RE: FINALAIR POLLUTION PERMIT-TO-INSTALL  
Facility ID: 0302020012  
Permit Number: P0114527  
Permit Type: Initial Installation  
County: Allen

## Response to Comments

Facility ID:	0302020012
Facility Name:	Lima Refining Company
Facility Description:	Petroleum Refinery and Storage
Facility Address:	1150 South Metcalf Street Lima, OH 45804 Allen County
Permit:	P0114527, Permit-To-Install - Initial Installation
A public notice for the draft permit issuance was published in the Ohio EPA Weekly Review and appeared in the The Lima News on 8/27/2013. The comment period ended on 10/07/2013.	
Hearing date (if held)	<b>10/1/13</b>
Hearing Public Notice Date (if different from draft public notice)

**Table 17-2**

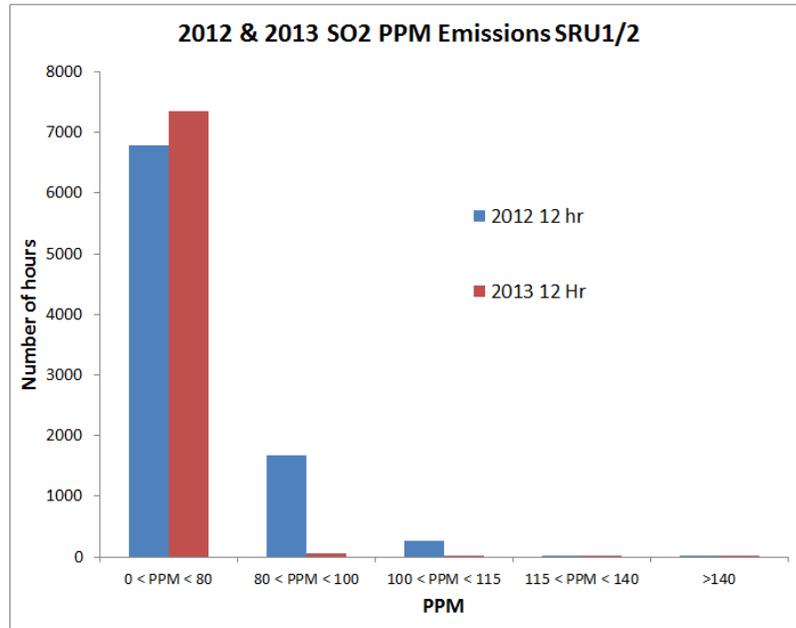
The company has stated that concentrations as high as 250 parts per million sulfur dioxide can occur, but those events are rare and are related to process upset conditions. Thus, the new SRU can be considered as if were operating as two types of sources: first - it operates year round at 70 parts per million sulfur dioxide; and second – it has intermittent operation on an infrequent basis, at levels up to 250 parts per million sulfur dioxide.

The data in Table 17-1 shows, that typically, operation is less than ½ percent of the total operating hours when the SRU performance exceeds 115 parts per million sulfur dioxide, for a total of less than 40 hours per year. Table 17-2 below shows the typical distribution of SRU performance data over for the past few years. This table demonstrates the concentration in the existing SRU stack is less than 80 parts per million sulfur dioxide, as a 12-hr average, for the large majority of the operating hours.

The company conducted short term dispersion modeling of the new SRU (Claus 3) using emissions rates corresponding to the approximate 115 parts per million sulfur dioxide in the stack at maximum process rates. This is virtually double the typical expected concentration for sulfur dioxide under normal operations and, thus, is already a conservative value. Emissions above this level would only occur on an intermittent basis as shown in the historic sulfur dioxide concentration data from the two existing SRUs.
